# ADDENDUM #03 TO CONTRACT DOCUMENTS

**Project:** DTCC Terry Campus – Healthcare Center of Excellence  
Dover, Delaware

**Subject:** **ADDENDUM #03**

**1 FIRST FLOOR FINSH PLAN**  
 SCALE: 1/4" = 1'-0"

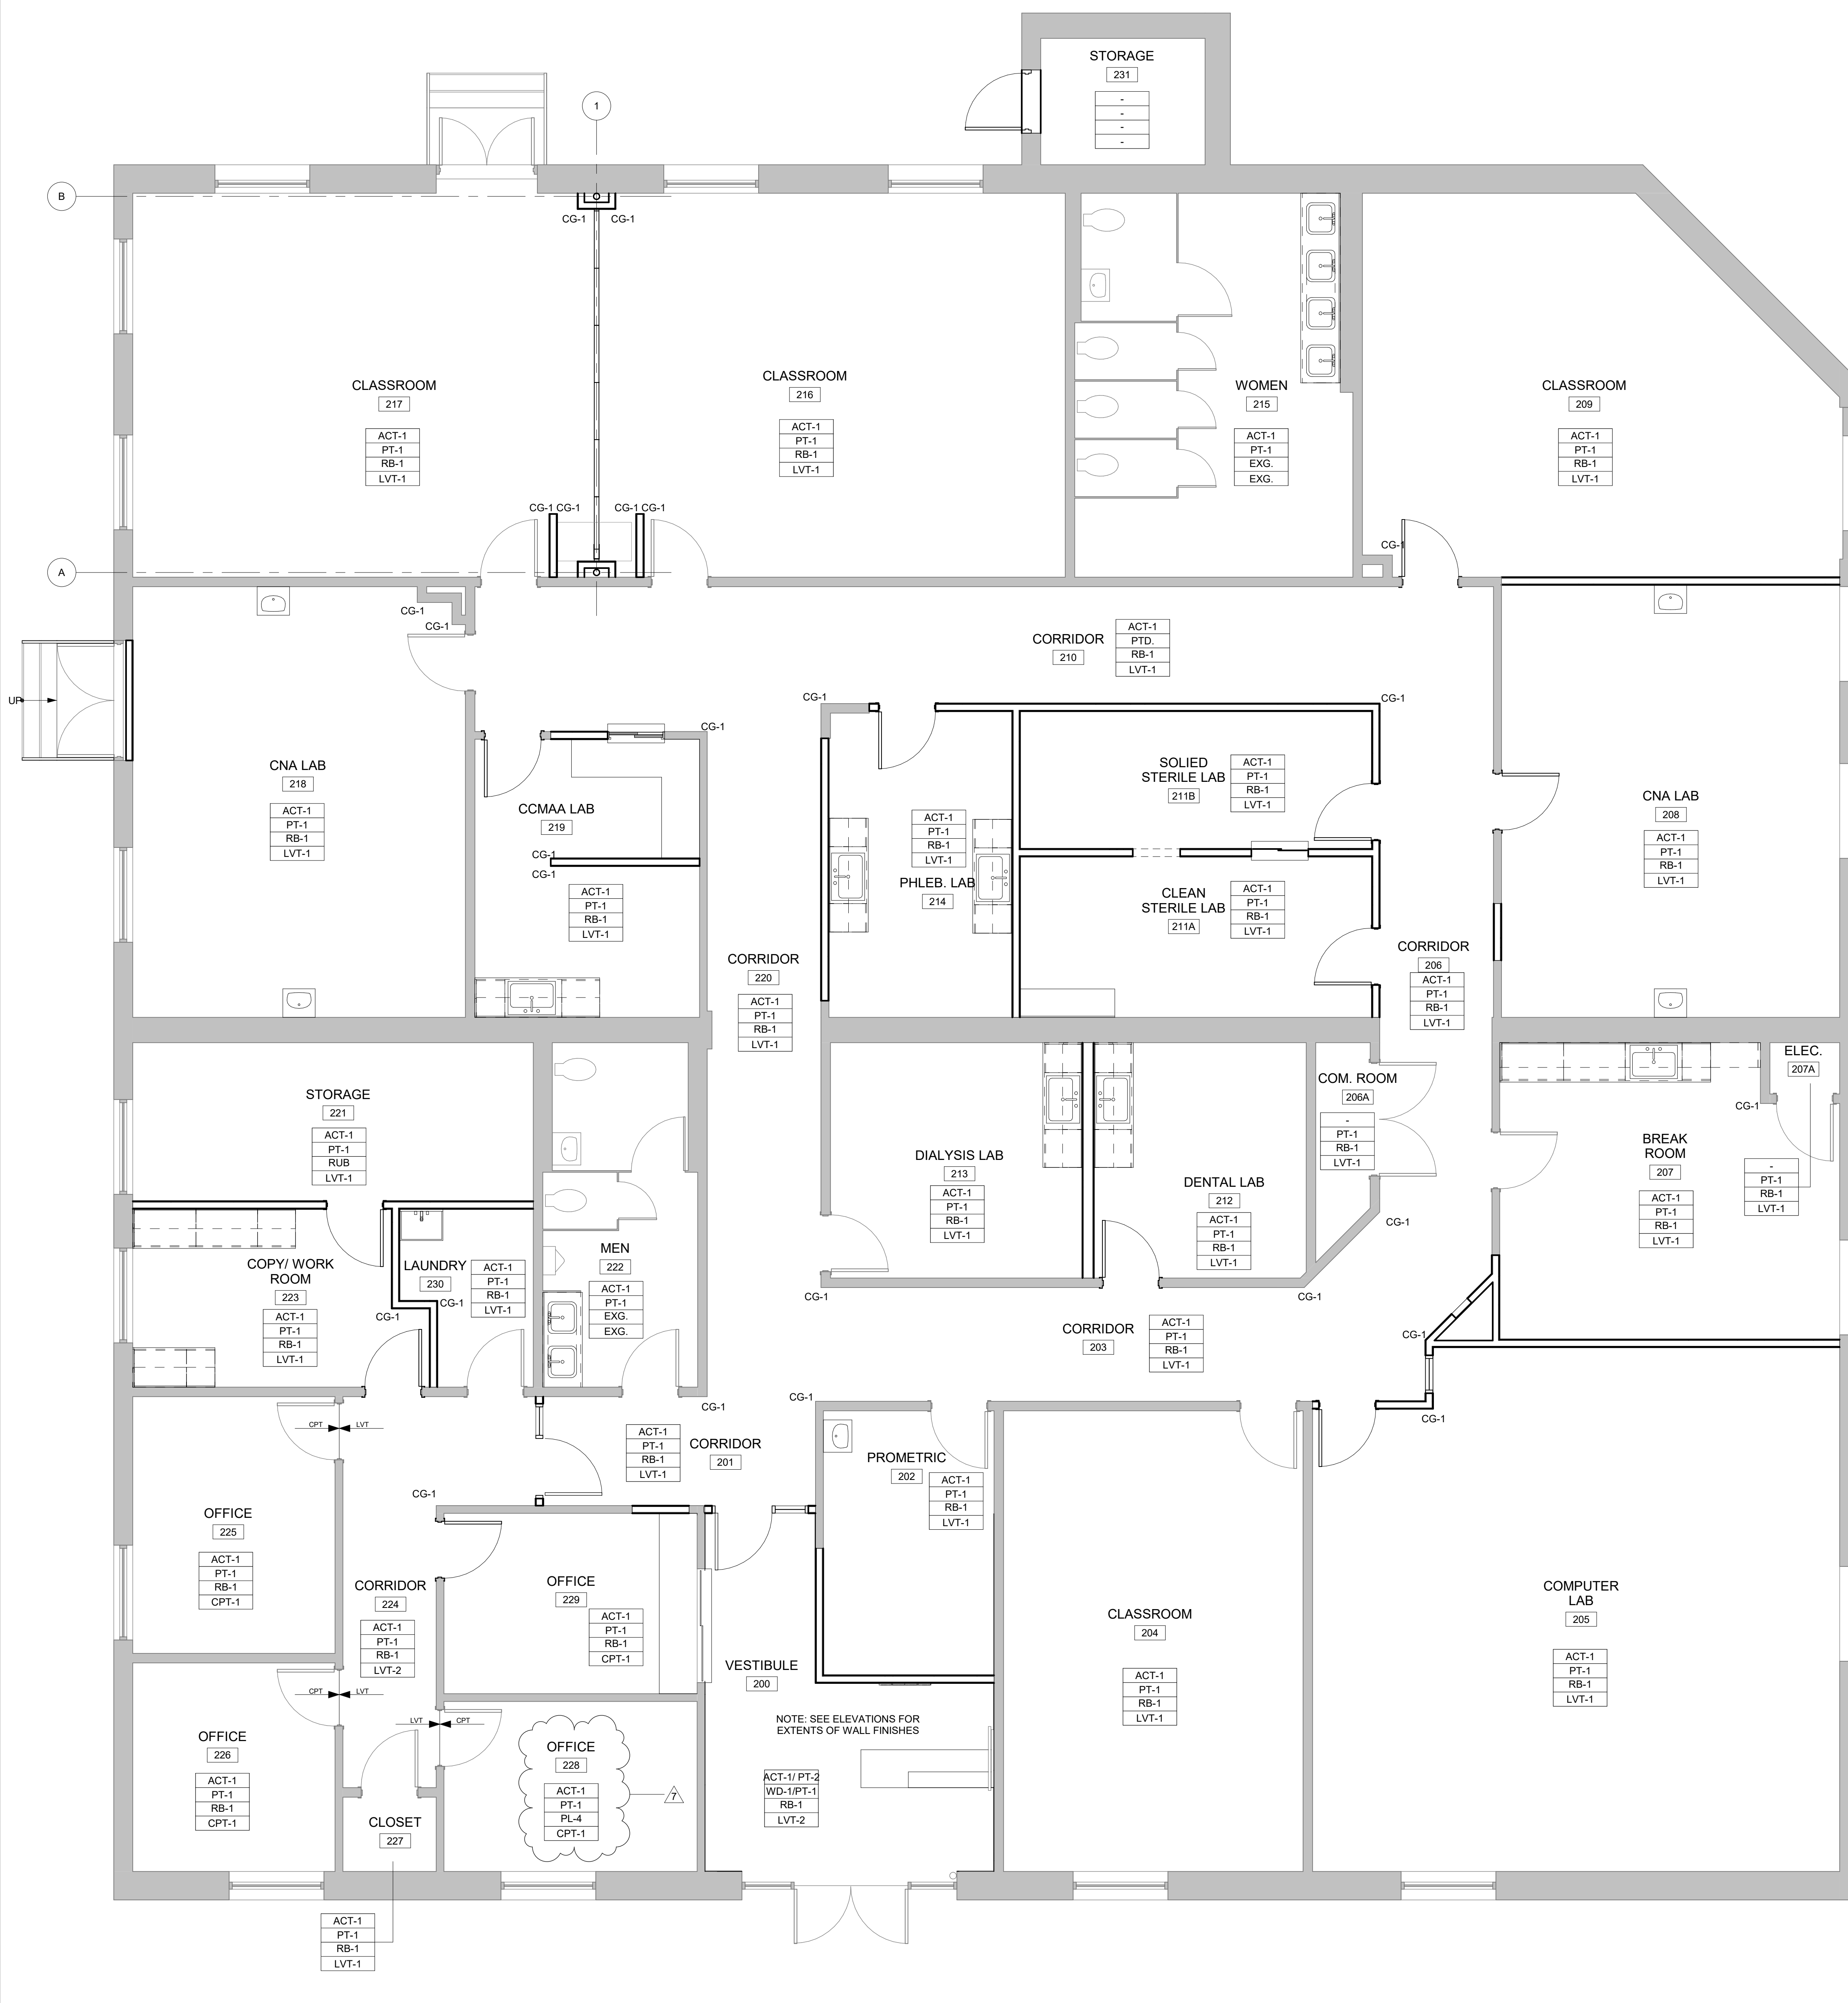
3.9	<p>Q3.9: Elevations 11 through 15 on A701 show “1 x 3 Base, PL-4” in Vestibule 200, while A103 shows RB-1. Please clarify.</p> <p>Q3.9: Provide PL-4 where occurs on drawing 11/A701, 12/A701, 13/A701, 14/A701 and 15/A701. REVISE drawings 1/A103 wall base in “VESTIBULE 200” from RB-1 to PL-4.</p>

3.10	<p>Q3.10: The Finish Legend on A103 shows ceiling type ACT-2, which is not shown on the reflected ceiling plan. Please confirm ACT-2 should be deleted.</p> <p>A3.10: ACT-2 is not used and can be deleted.</p>

Item	Description
1	A103 – FIRST FLOOR FINISH PLAN A. DELETE “ACT-2” from “FINISH LEGEND” in its entirety. B. REVISE room tag for wall base in VESTIBULE 200 to “PL-4”.
